U.S. Army Corps of Engineers Information Needs – June 2009

Preparation for Bellefonte Units 3 and 4 Corps of Engineers Site Visit, July 8-10, 2009

COE INFORMATION NEED: COE-4

COE INFORMATION NEED: COE-5

FIGURE 5.6-1
Transmission Sensitive Habitat

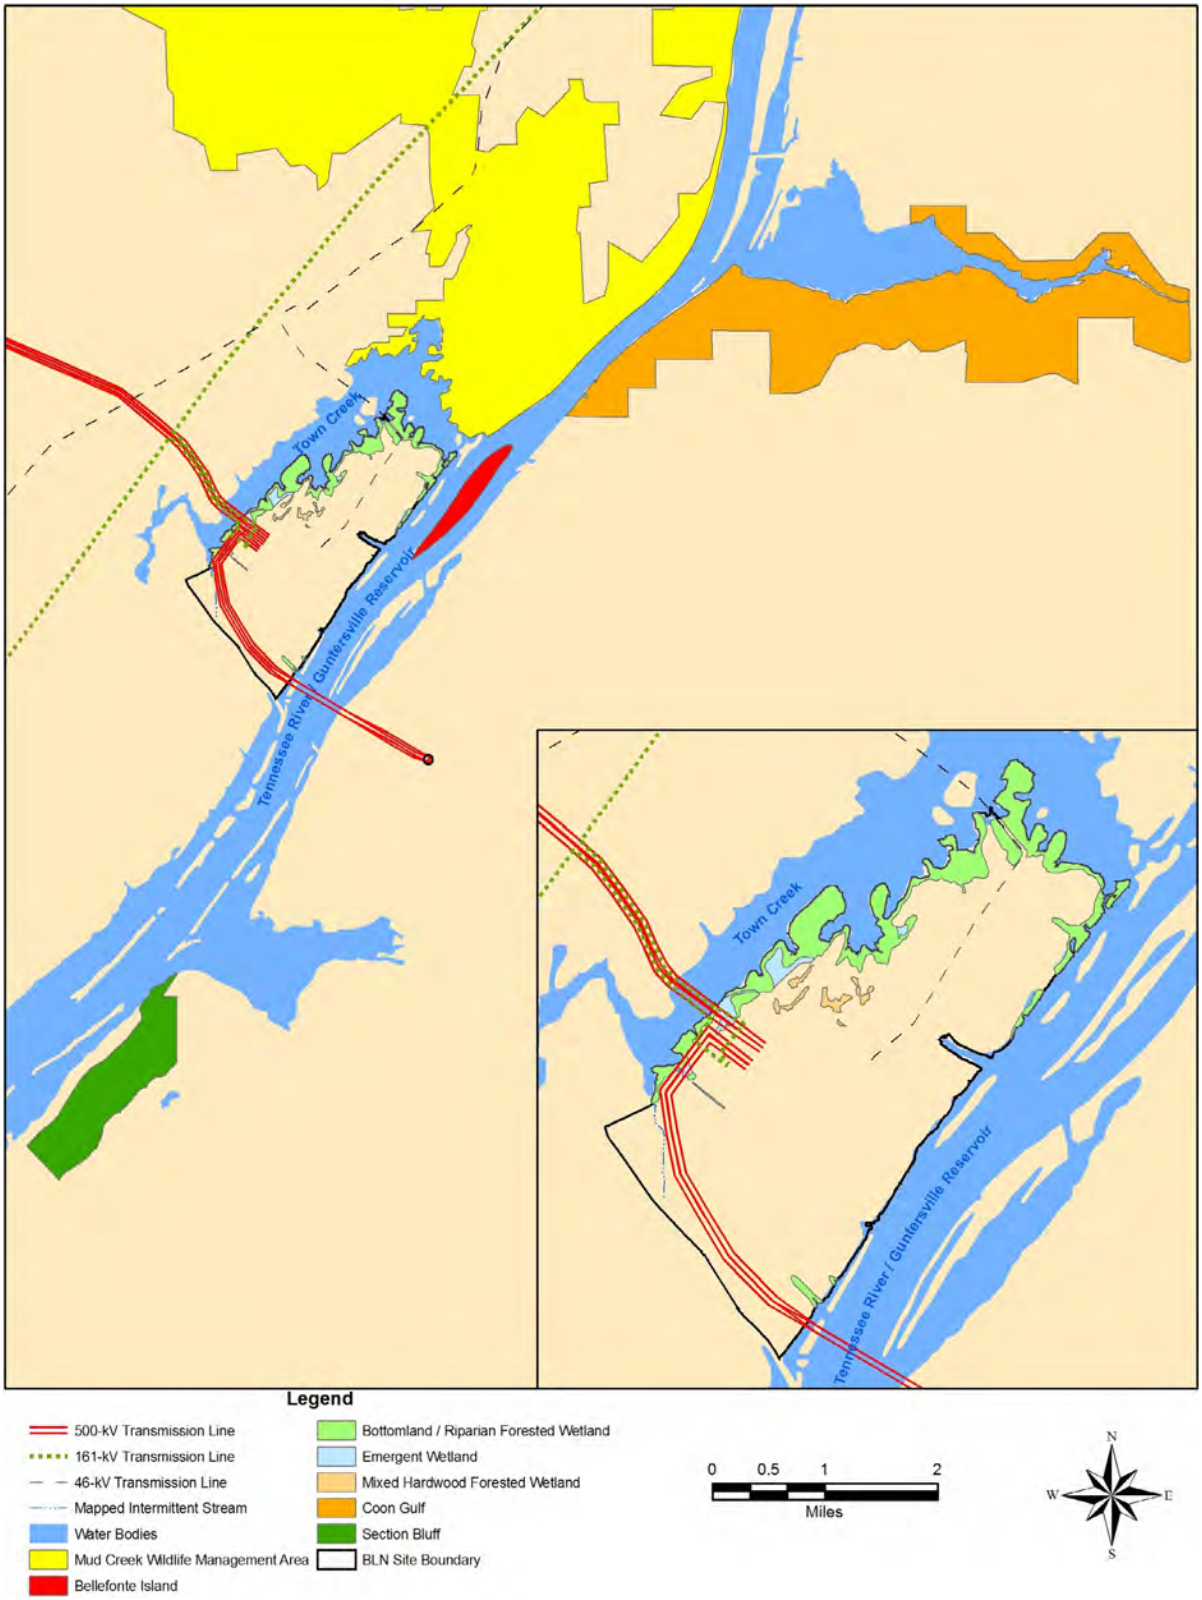
Provide an SME and supporting data and information/references to discuss the techniques to be used by TVA to avoid and minimize impacts to waters of the U.S. at the Bellefonte Site due to the pre- construction, construction and operation of Bellefonte Units 3 and 4. The description should include but not be limited to:

- A description of the criteria used to identify, evaluate, and screen on-site project alternatives regarding structure placement, temporary work areas, haul roads, etc.,
- considerations to reduce project footprint,
- considerations to reuse/upgrade existing infrastructure,
- temporary work areas and staging areas including restoration activities planned,
- construction access and permanent access roads,
- site grading and permanent structures, parking areas, etc.,
- methods to minimize adverse effects to water quality,
- methods to minimize adverse effects to natural and cultural resources,
- methods to minimize shore erosion from discharge line extending into Guntersville Reservoir

Effects of transmission corridor maintenance on terrestrial and aquatic ecosystems during operations are addressed in Section 5.6, along with TVA maintenance procedures and measures

to limit impacts. Figure 5.6-1 illustrates habitat that is sensitive to transmission lines/corridor maintenance, and the figure is provided as an attachment.
